SUMMER LANE
PAGHAM

SuDS FEATURES
HEADWALL
CONSTRUCTION DETAILS
SHEET 1 OF 2

DSM/E4761/433 C

Headwall SW-32

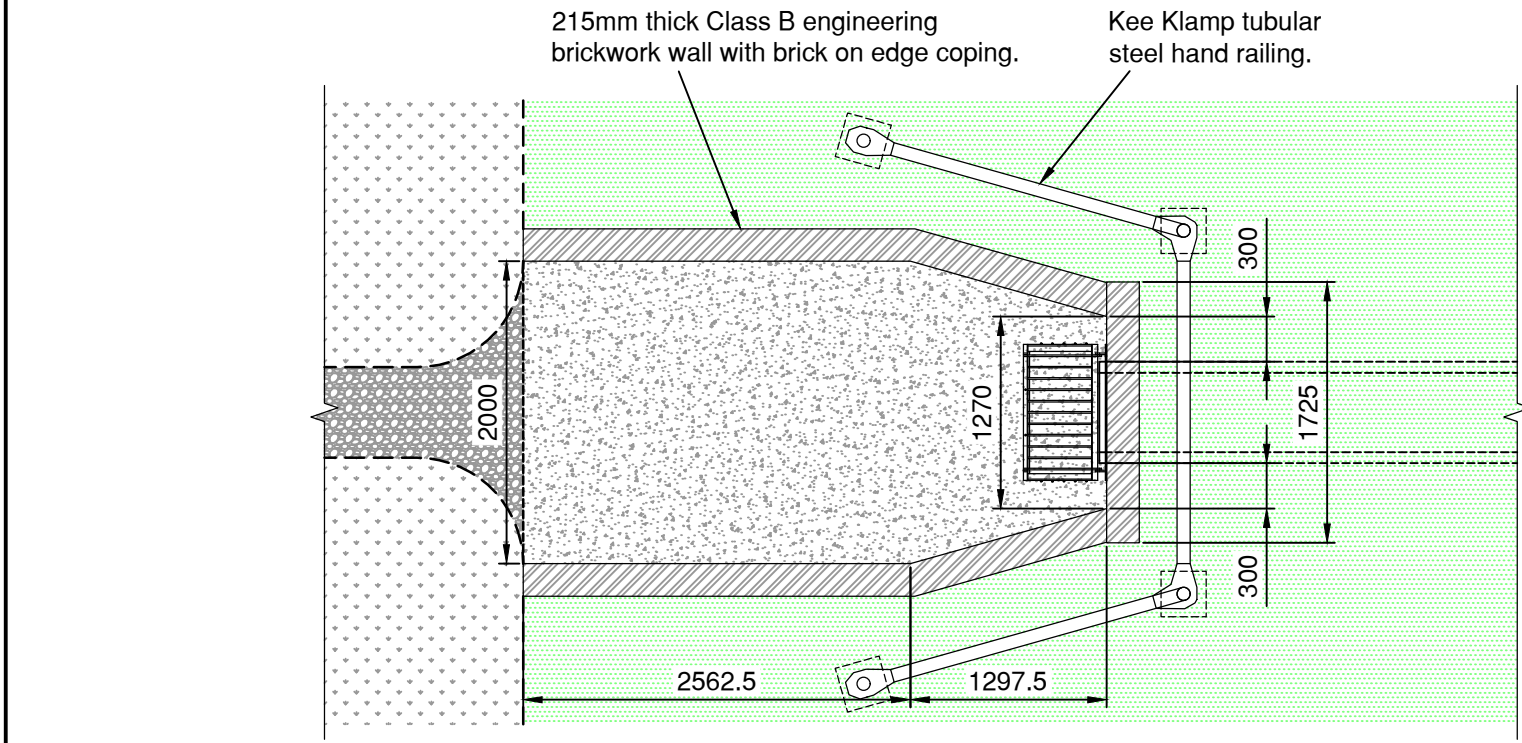
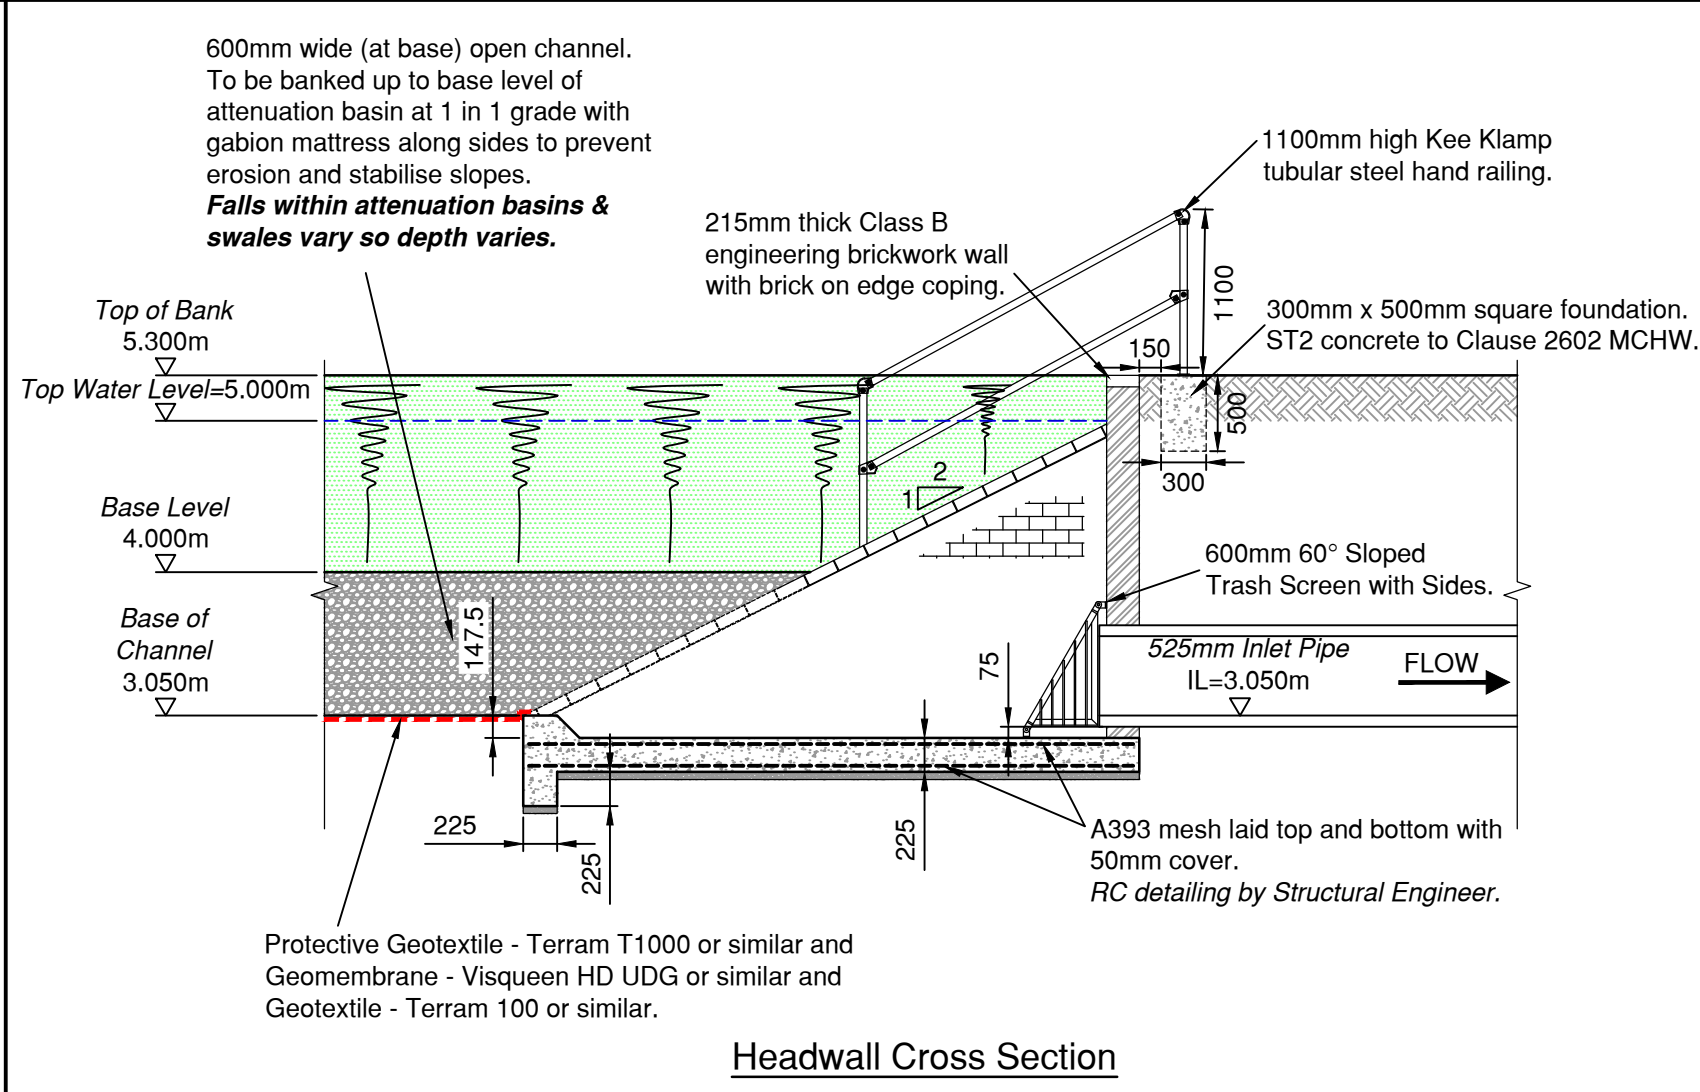
Rev.	Date	Details	By	Chkd	Appd
C	14.07.20	SW-32 Base level revised to reflect plan in accordance with drainage comments received from Arun District Council on 07/07/2020. (Revision clouds omitted for clarity).	LD	TK	TRS
B	03.07.20	SW-32 amended to reflect revised incoming pipe, invert and base channel levels revised. Headwall SW-9 grille indicated in accordance with drainage comments received from Arun District Council on 23/06/2020. (Revision clouds omitted for clarity).	LD	TK	TRS
